I-20/287/820 Interchanges: Problematic Areas

Issue Overview:

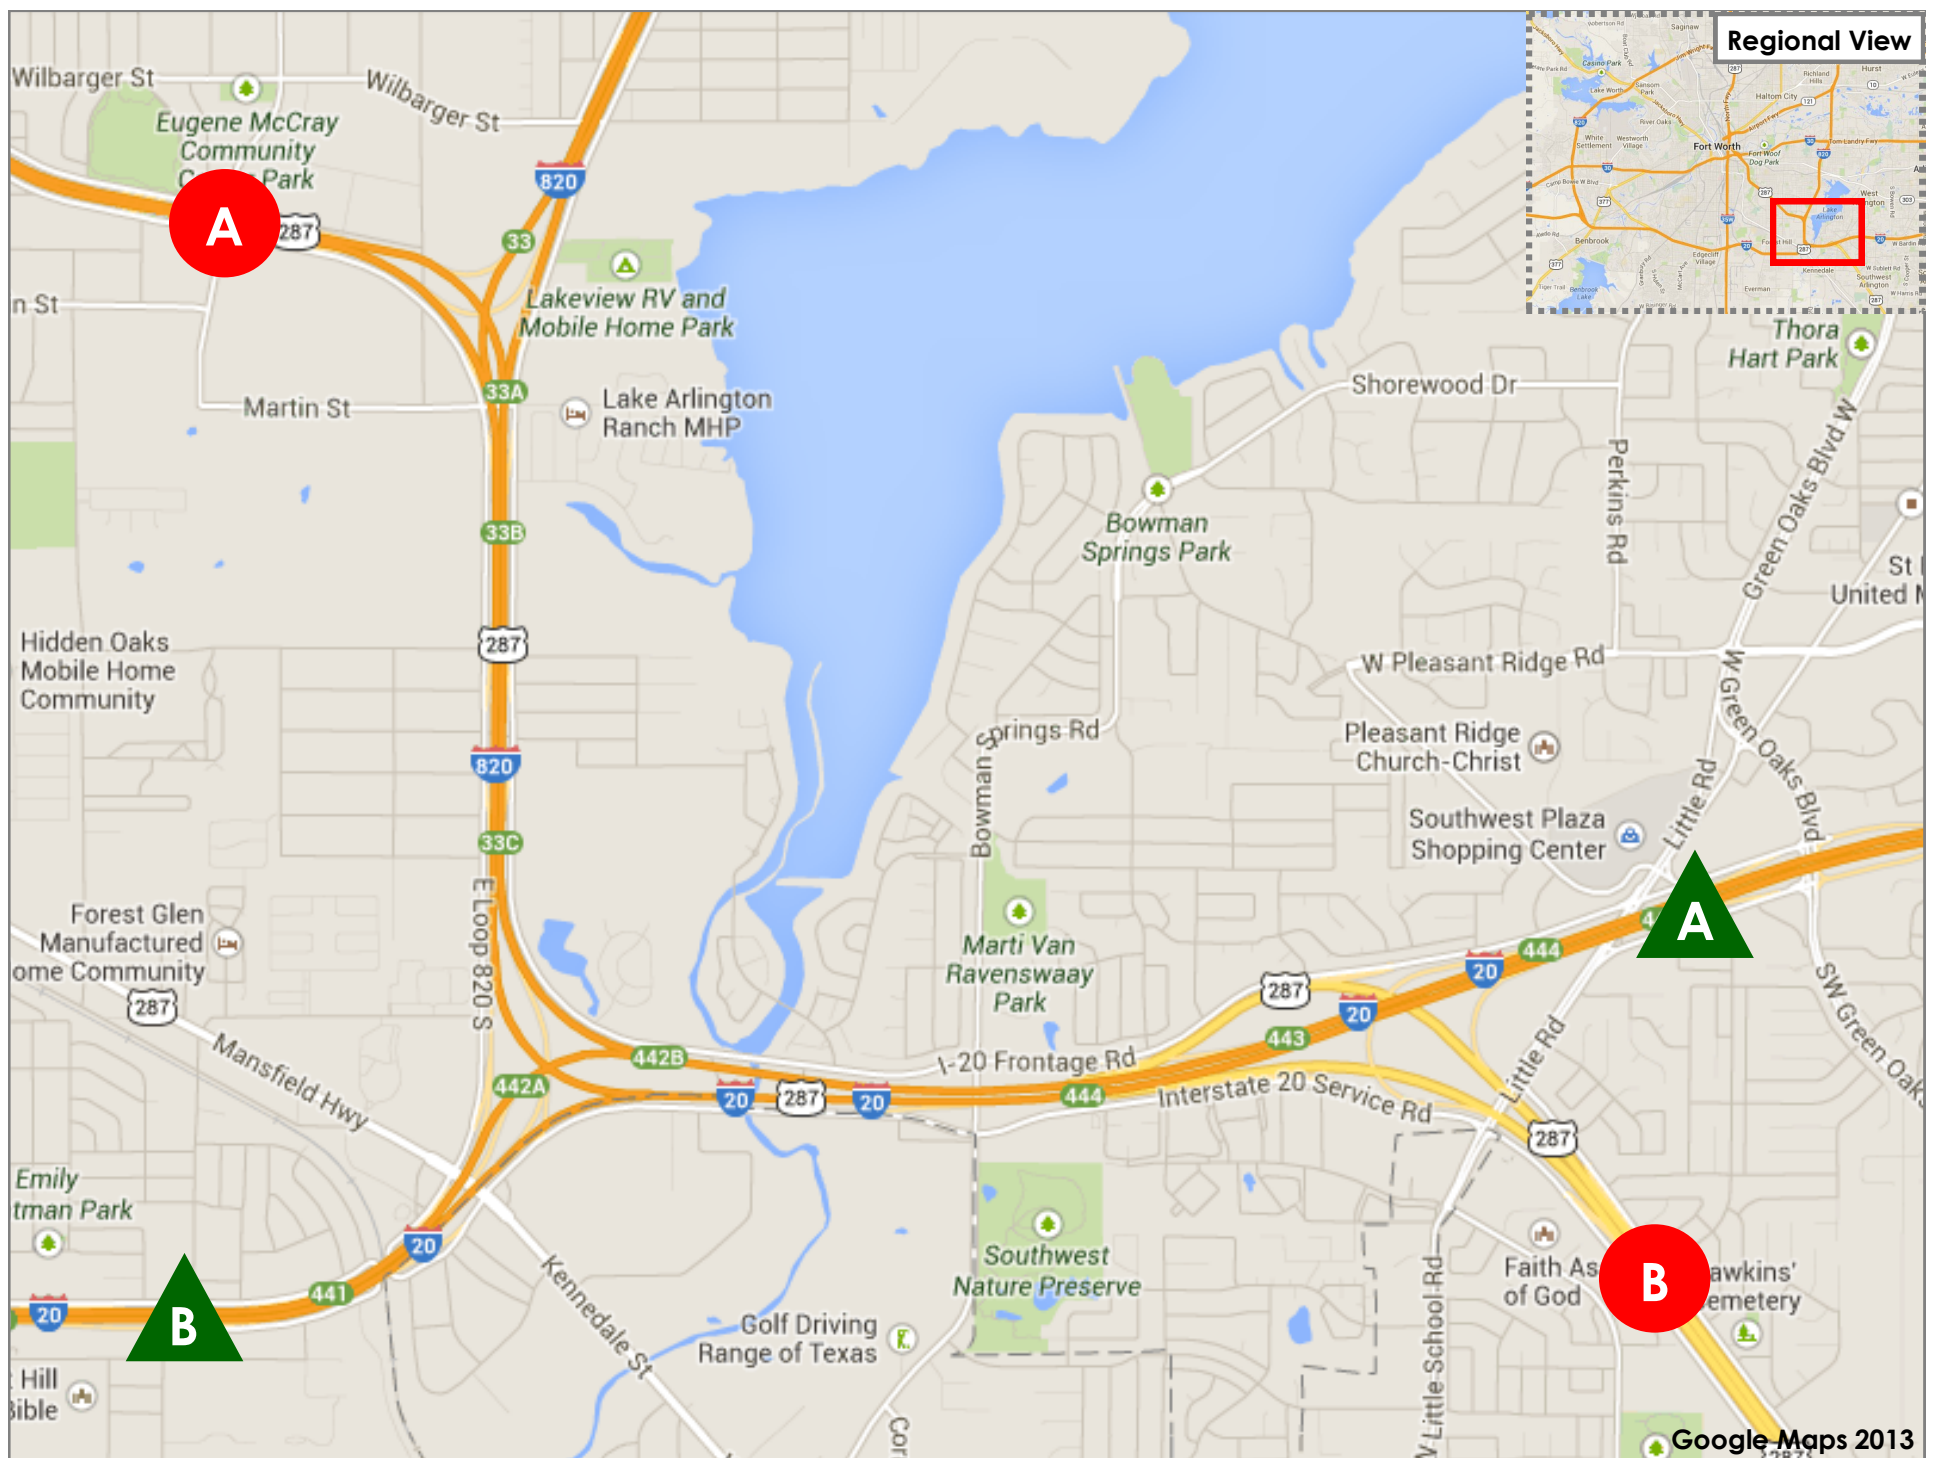
In general, the 287/I-20/820 interchanges are poorly designed and are unable to handle current traffic levels, much less projected future traffic. The number of lane changes that drivers must endure to move north, south, east, and west through this portion of Tarrant County lead to overall congestion and generally unsafe conditions. The left exit for Business 287 further complicates and interrupts traffic patterns. Entrance and exist ramps are, in general, poorly designed and create severe congestion and unsafe conditions.

SOUTHBOUND (A to B): *Traveling South on 287, the driver must stay right in order to get onto 820, then quickly move into the left lane to get onto I-20 East, then move back to the right lane to get to 287 South.*

NORTHBOUND (B to A): *Traveling North on 287, the driver must get into the left lane to move onto I-20. This lane then becomes the right lane of I-20, which the driver must stay on to merge onto 820, and then move 2 lanes to the left to get and stay on 287 North.*

WESTBOUND (A to B): *Traveling West on I-20, the driver must move 3 lanes to the left to stay on I-20 West (right 2 lanes redirect to 820 North), but must avoid accidentally exiting I-20 onto Business 287 via the left-side exit ramp.*

EASTBOUND (B to A): *Traveling on I-20 East, the driver must stay in the right lane to stay on I-20 (left 2 lanes redirect to 820), then move left to stay on I-20 East (right lanes redirect to 287 South).*
